Final Drainage Report
for
Windingwalk Filing 1
at
Meridian Ranch

EL PASO COUNTY, COLORADO

December 2017

PCD File No.'s PUDSP-18-002 and SF-18-002

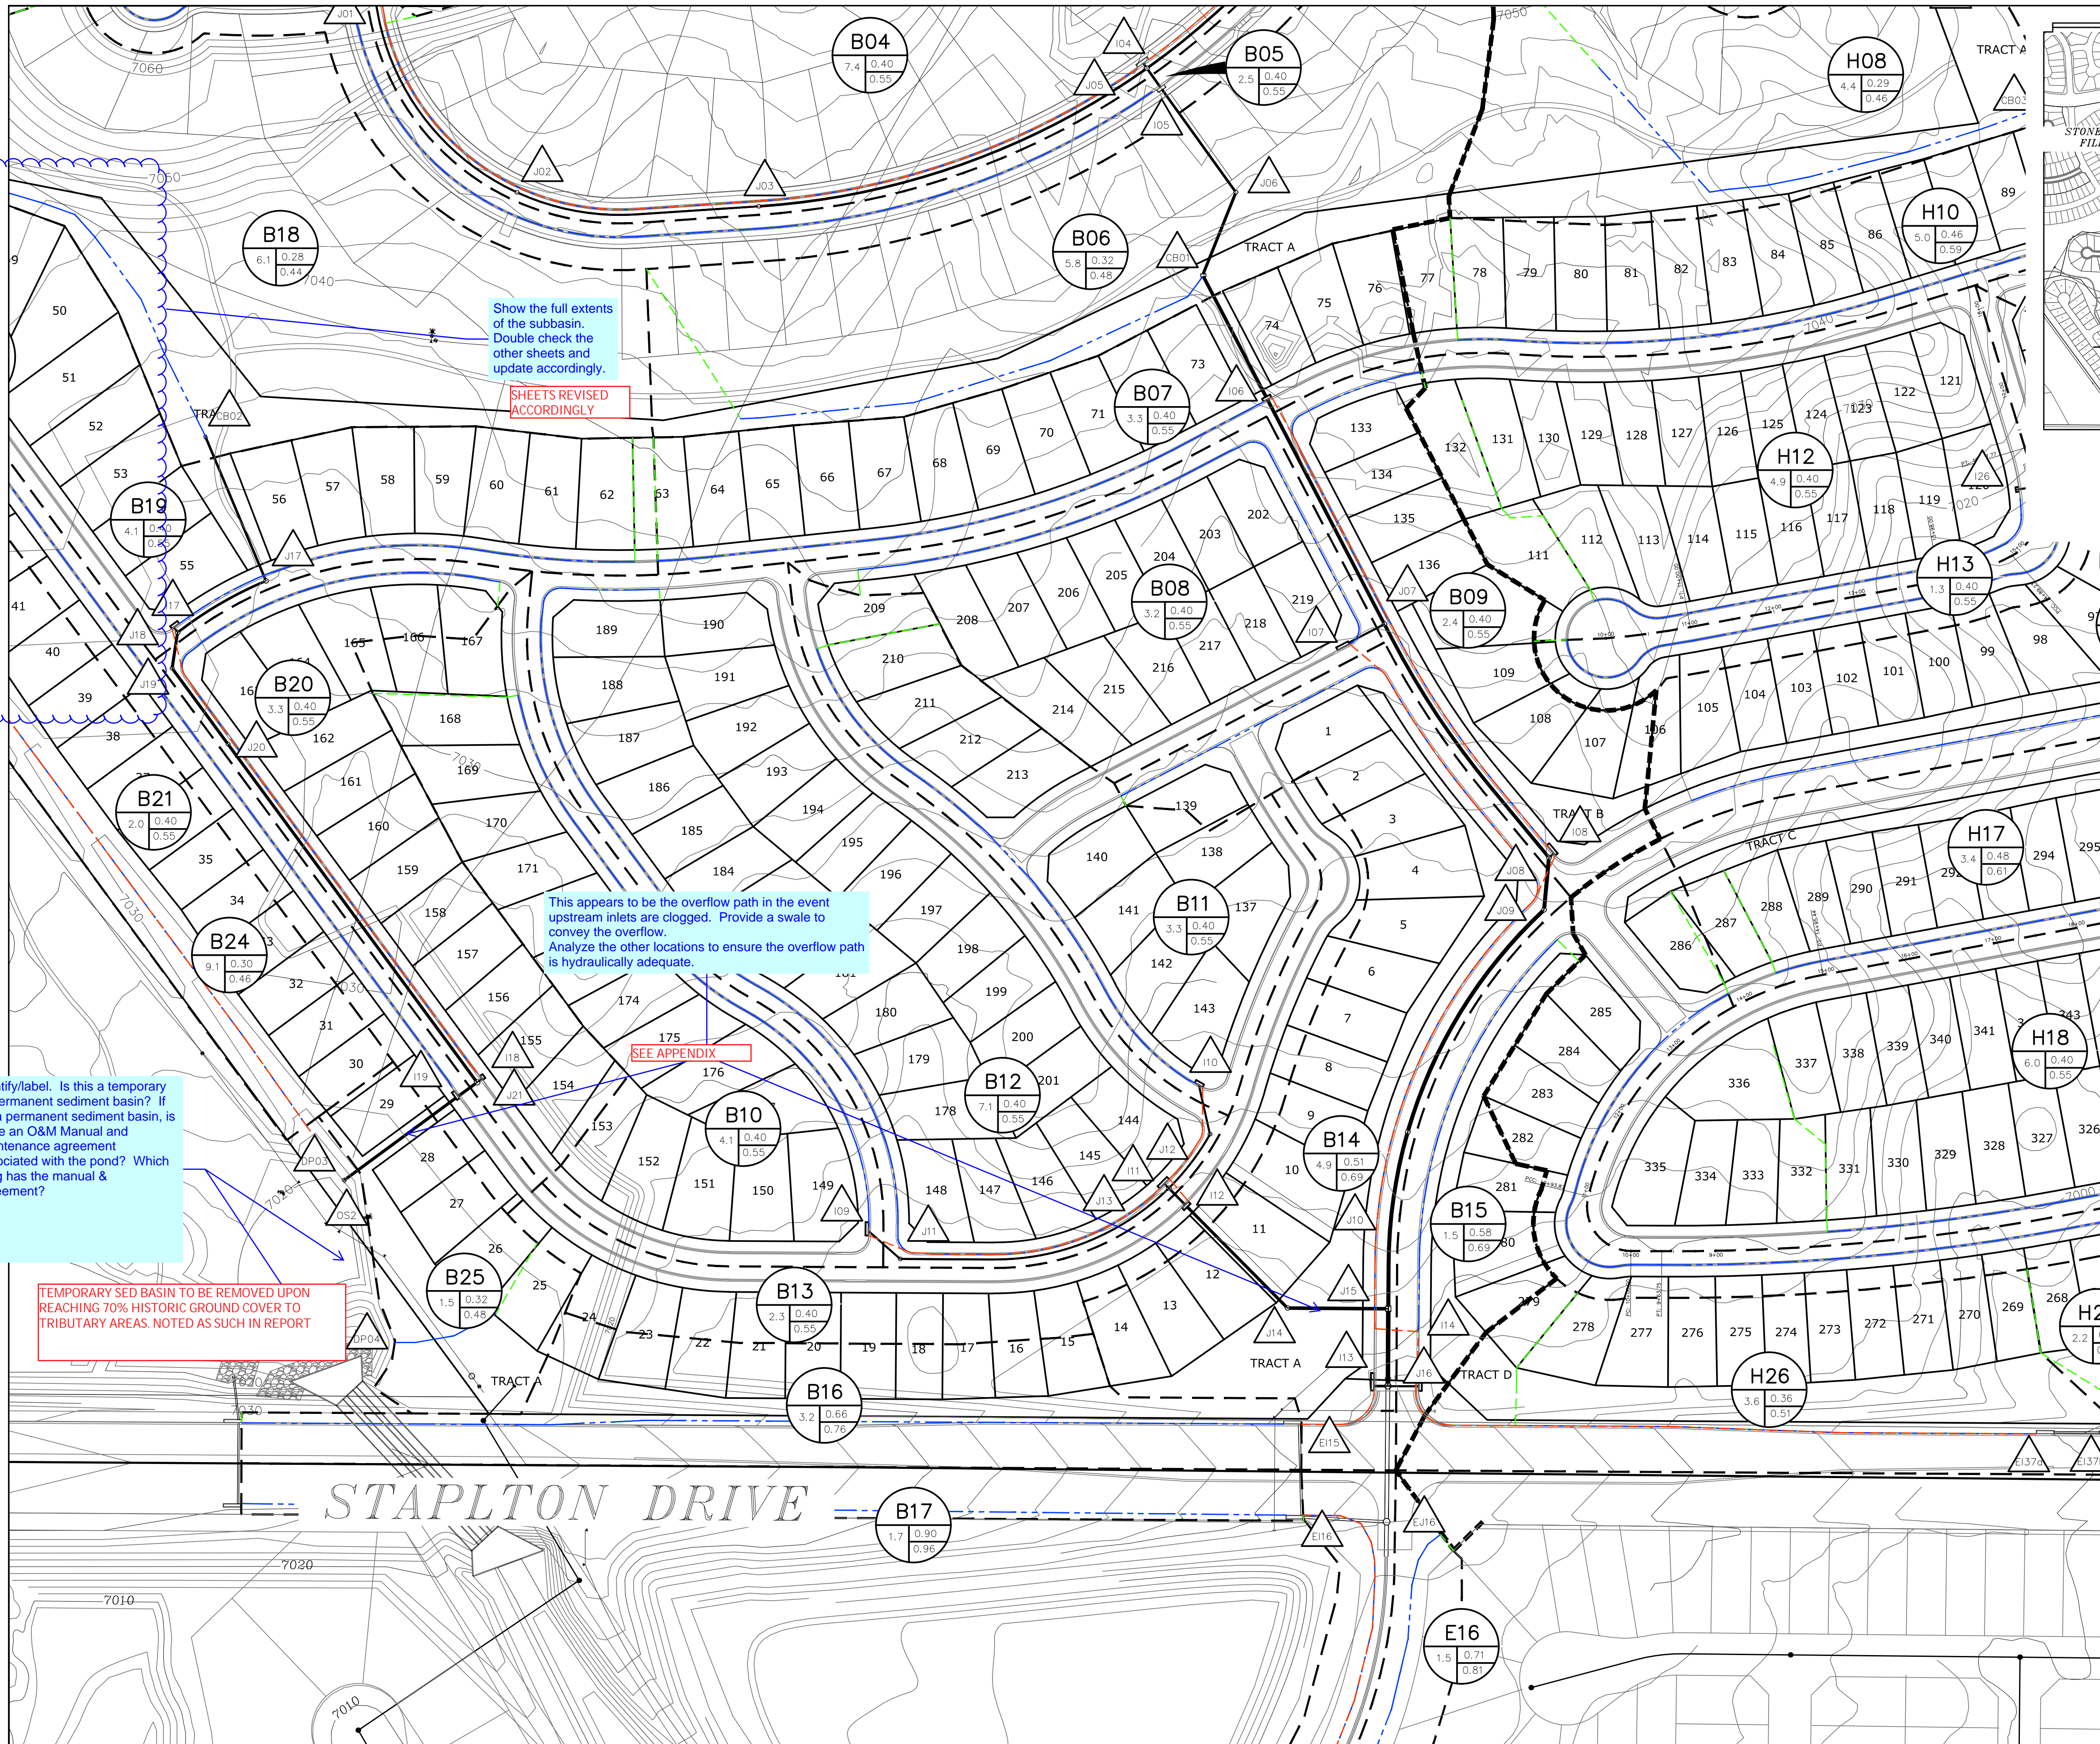
Show the full extents of the subbasin. Double check the other sheets and update accordingly.

This appears to be the overflow path in the event upstream inlets are clogged. Provide a swale to convey the overflow. Analyze the other locations to ensure the overflow path is hydraulically adequate.

SHEETS REVISED ACCORDINGLY
